No. 0560-210  
ATA Code 32-20

### Kit No. 23-8007-1 S

**SUBJECT:** LANDING GEAR (NOSE GEAR STEERING) – MODIFICATION OF NOSE GEAR CENTERING CABLE

NOSE GEAR CENTERING CABLE INSTALLATION

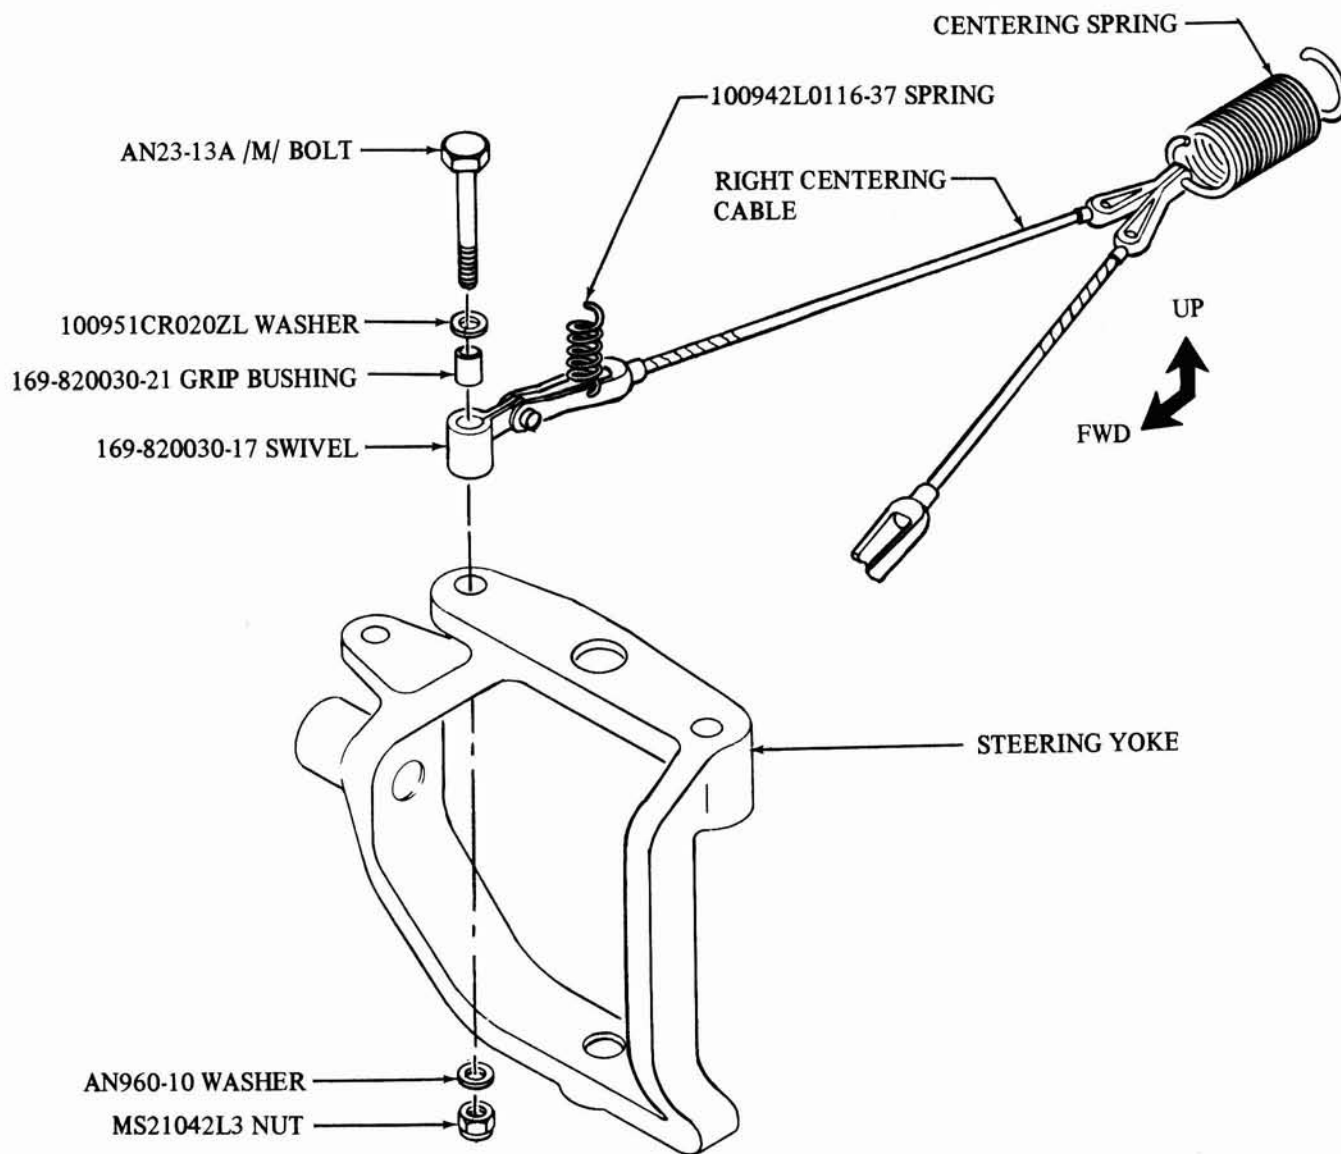
**DESCRIPTION:** The original right hand centering cable, grip bushing, swivel, and bolt are removed and new ones are installed. A clamp is installed on the right forward intake tube and a spring is connected from the clamp to the centering cable fork.

Install the clamp on the intake tube at a distance of one inch outboard from the side of the oil pan.

9. Attach the 100942L0116-37 spring to the right hand centering cable at the hole in the forward fork.
10. With the new spring installed it will be necessary to grind a recess in the engine mount to provide clearance for the spring. Use a file or hand grinder to remove metal from the area indicated on the ENGINE MOUNT illustration.
11. Clean, prime and paint the area from which metal was removed.
12. Remove the aircraft from the jacks.
13. Reinstall the lower engine cowl.
